V2500 Propulsion System — Nacelle

Subject: Transmittal of Revision 5 to Service Bulletin Number V2500-NAC-78-0150

NACELLE — POWERPLANT — TRANSLATING SLEEVE, THRUST REVERSER —  
MODIFICATION OF

V2500-NAC-78-0150

Translating Sleeve Modification  
Figure 1 (Sheet 1)

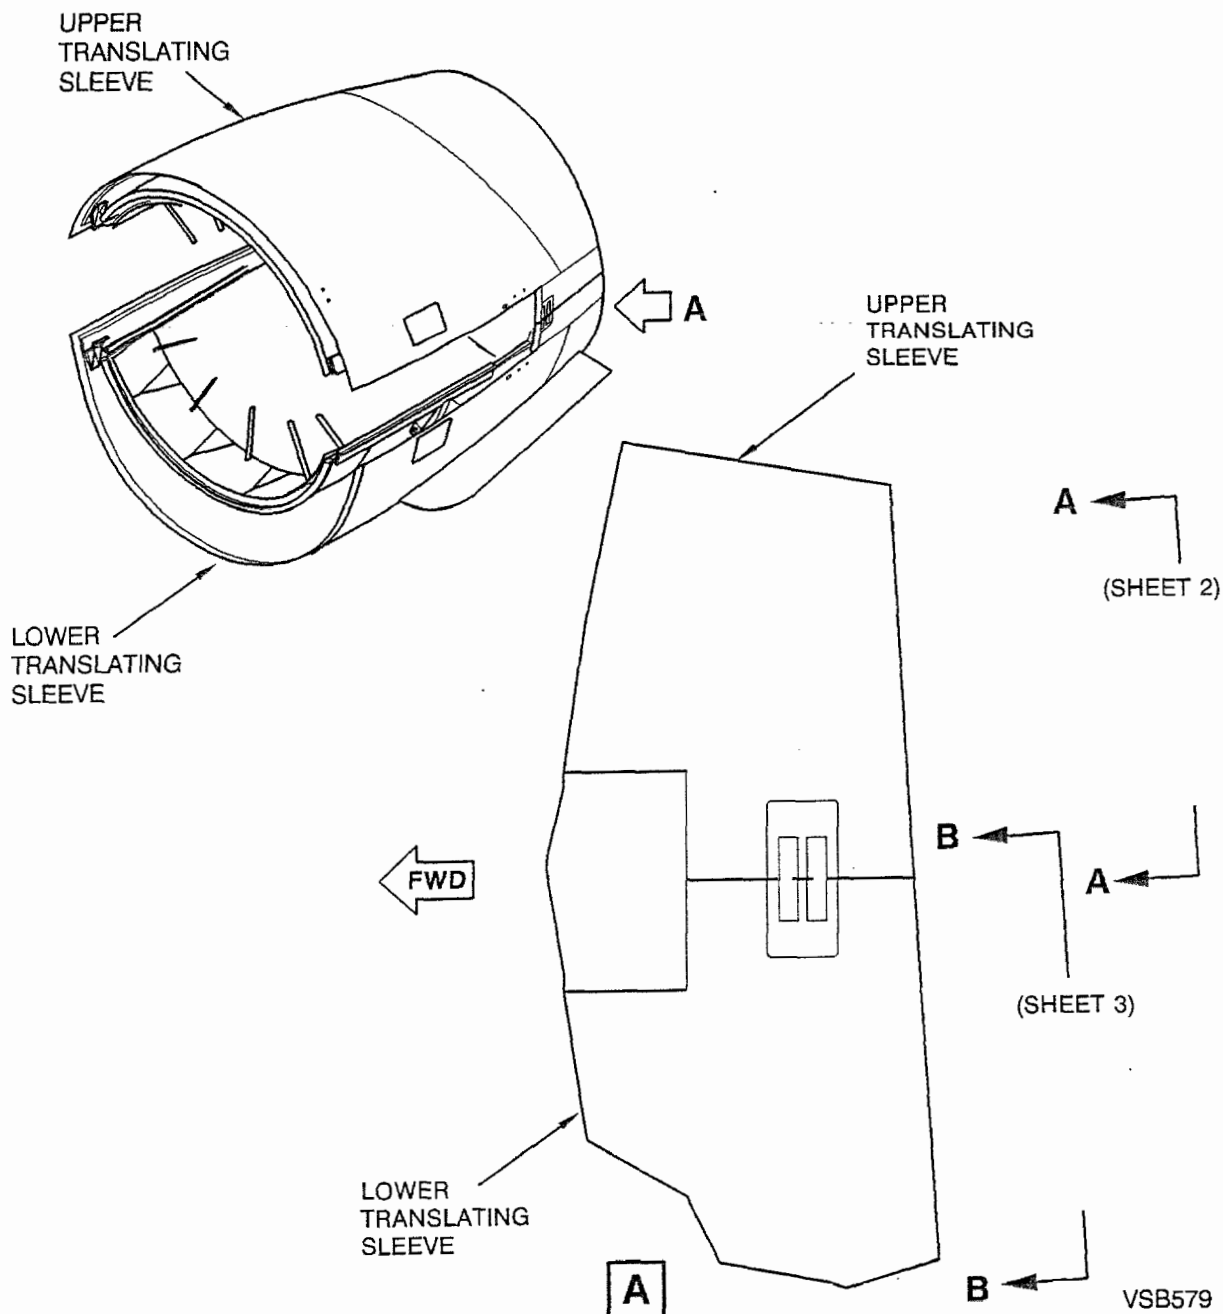
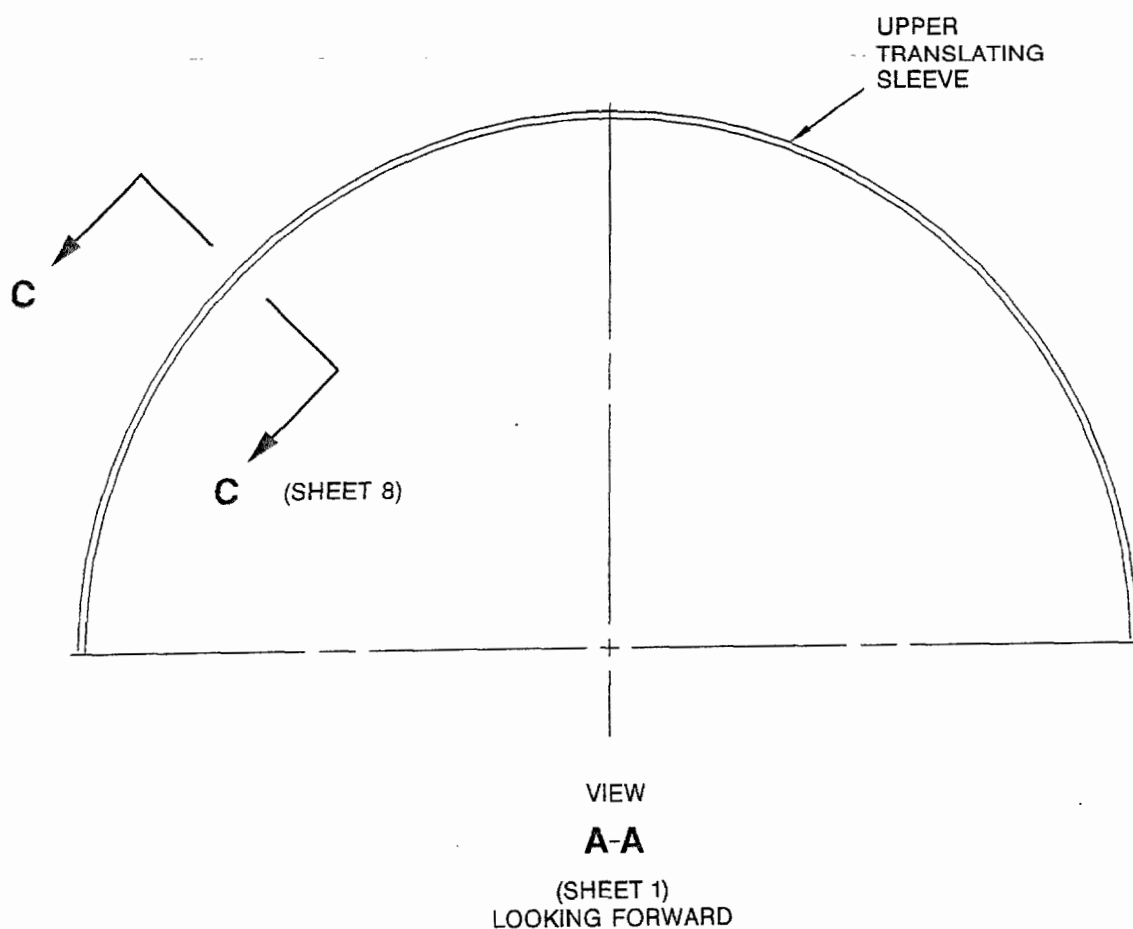
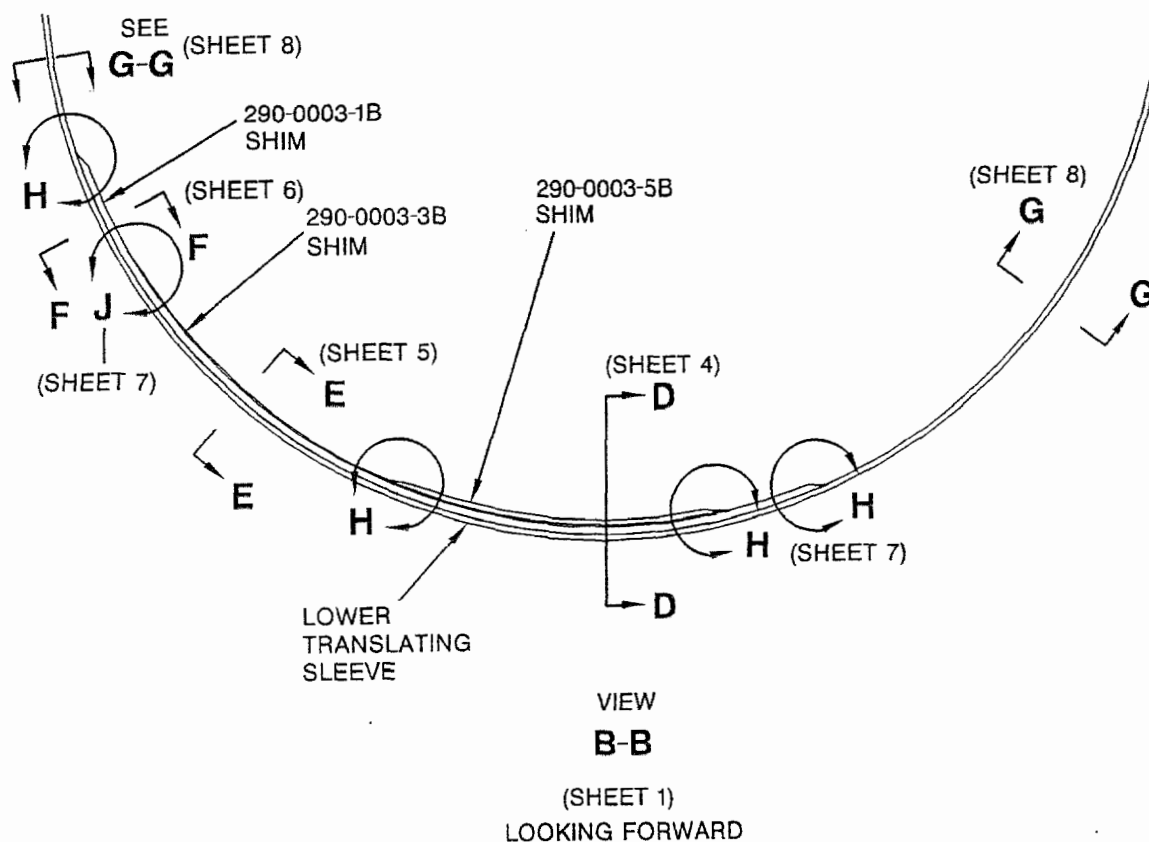
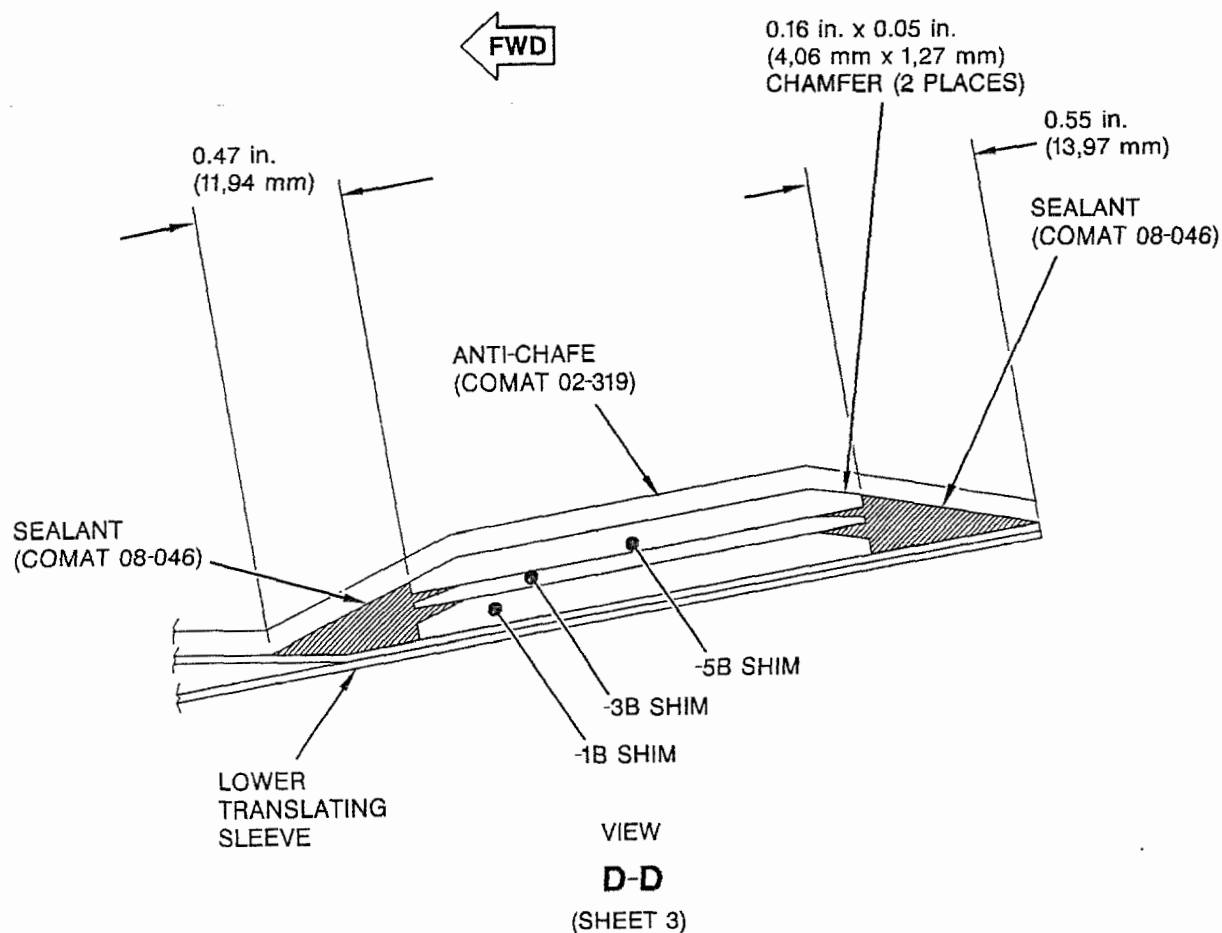
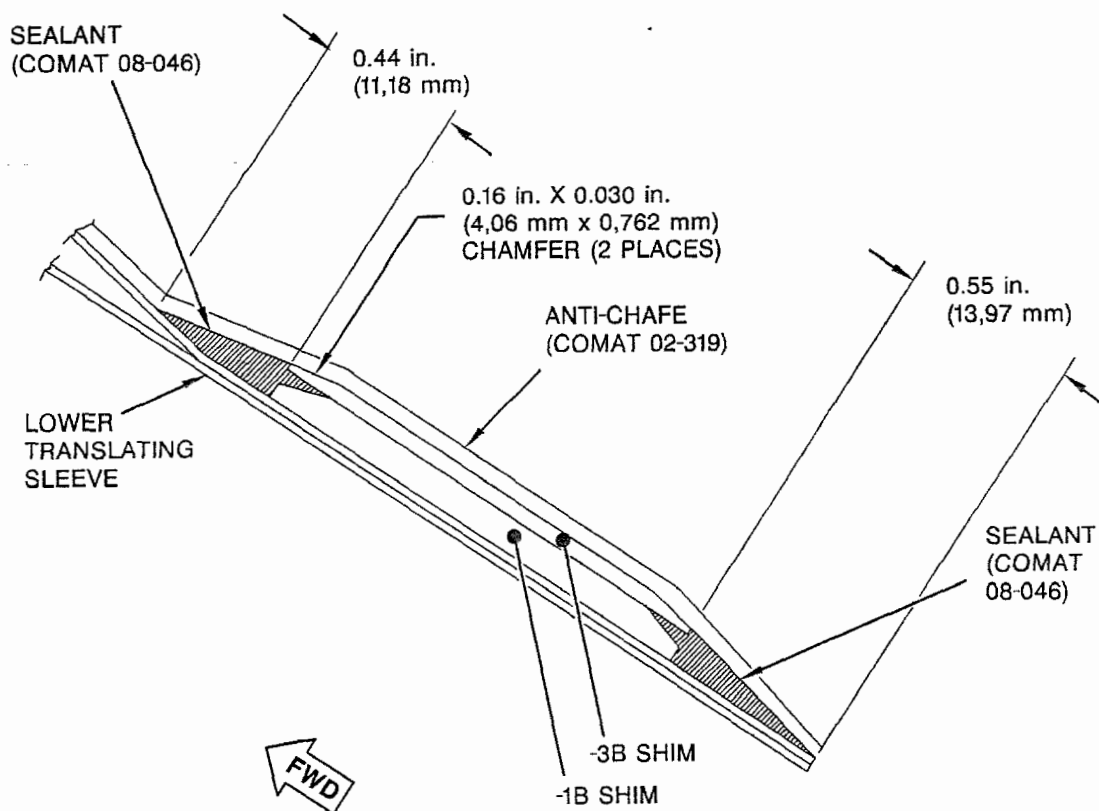
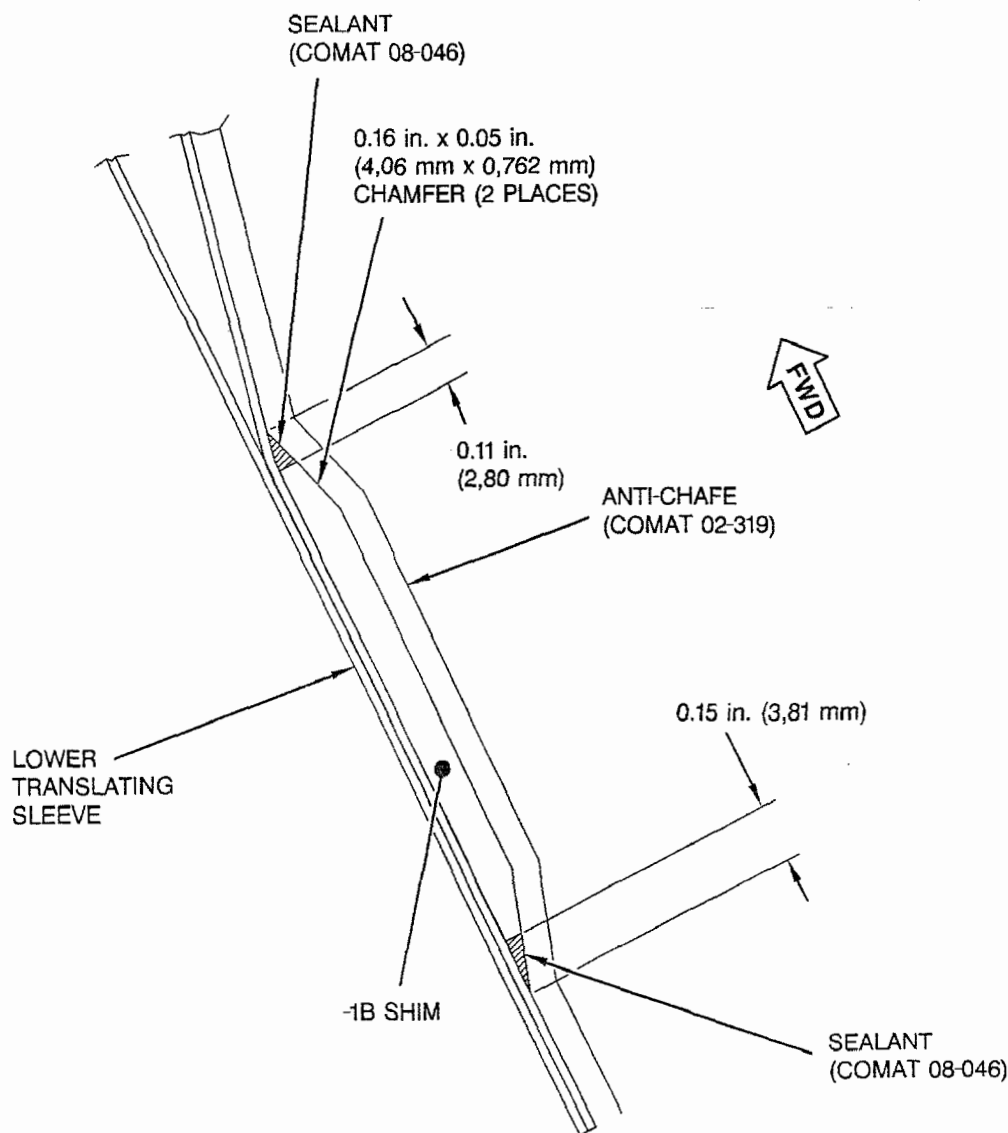
The shims at the aft end of the lower translating sleeve are chamfered and then a layer of abrasion resistant material is applied to the shims to reduce friction between the shims and CNA seals. Abrasion resistant material is also applied to the inner surface of the aft edge of the upper translating sleeve.

### C. Chamfer the shims on the lower translating sleeve to the dimensions shown in Figure 1.

- (1) Make the indicated areas of the upper and lower translating sleeve indicated in Figure 1 lightly rough with nylon scouring pads.

- (7) Apply aero-sealant (CoMat 08-046) around the shims on the lower translating sleeve as shown in Figure 1.
- (8) Cure the aero-sealant. Refer to the manufacturer's instructions.

- (1) To make minor dimensional changes to the size of the area of the translating sleeve to which the anti-chafe is applied.

Common Nozzle Assembly Lower Outer Duct Seal Inspection/Replacement  
Figure 2

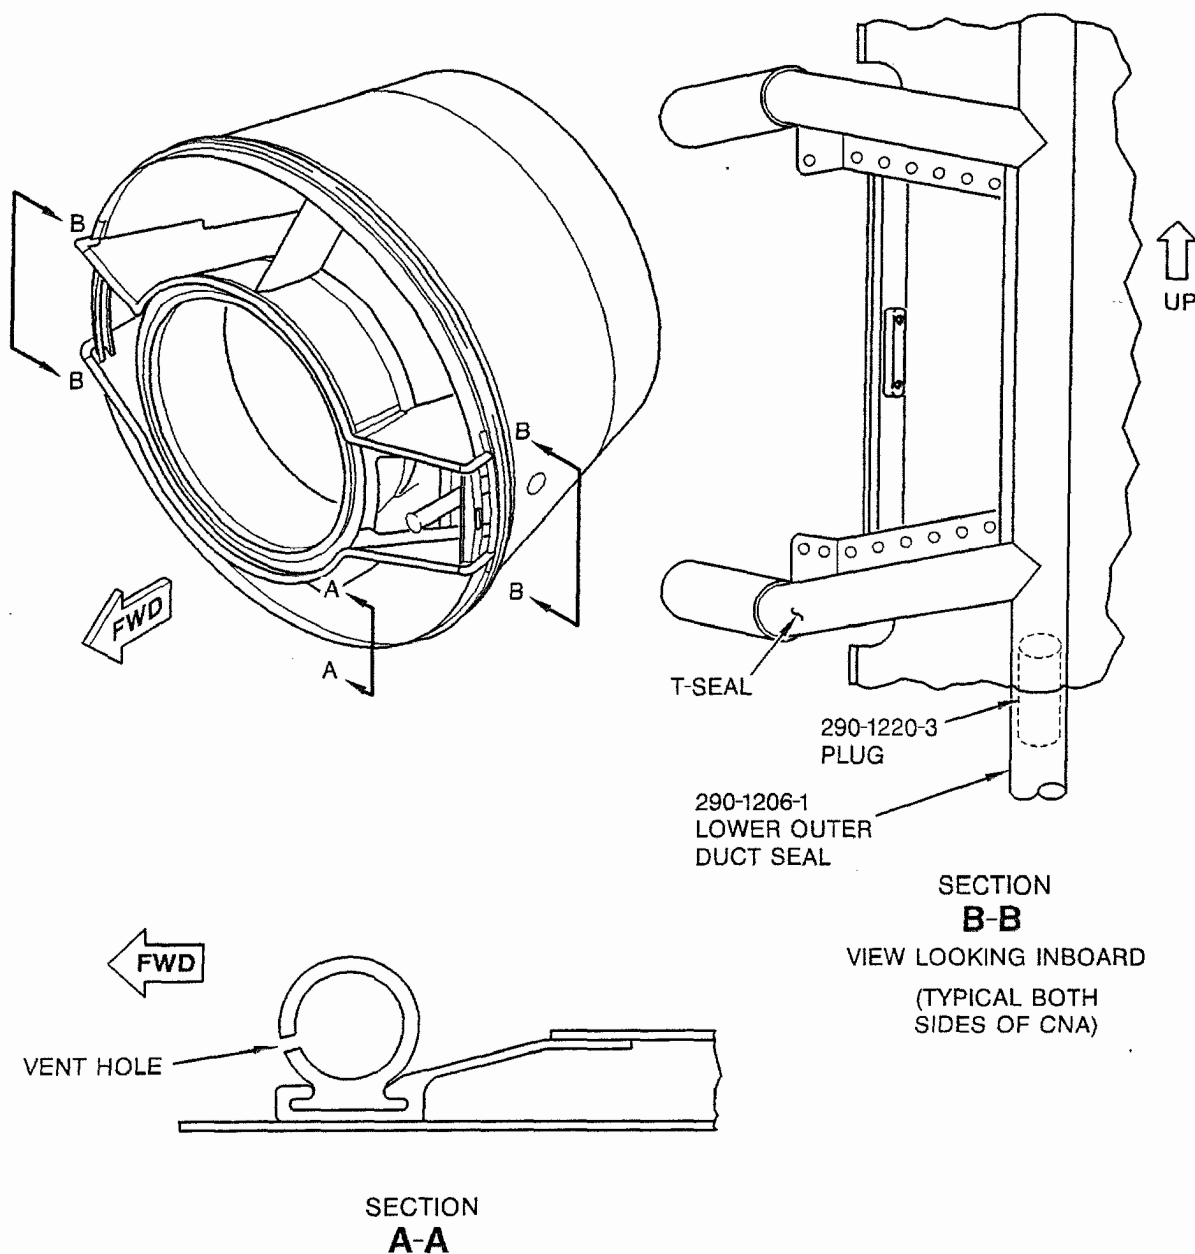
- (1) Examine the 290-1206-1 lower outer duct seal for damage.  
Refer to Figure 2.

- 1 If the abrasion does not penetrate the cover of the seal, accept the seal.
- 2 If the abrasion does penetrate the cover of the seal, replace the seal.

- 1 If no gouges, rips, or tears, accept the seal.
- 2 If any gouges, rips, or tears, replace the seal.

- (2) Replace the 290-1206-1 lower outer duct seal, if required.  
Refer to Figure 2.
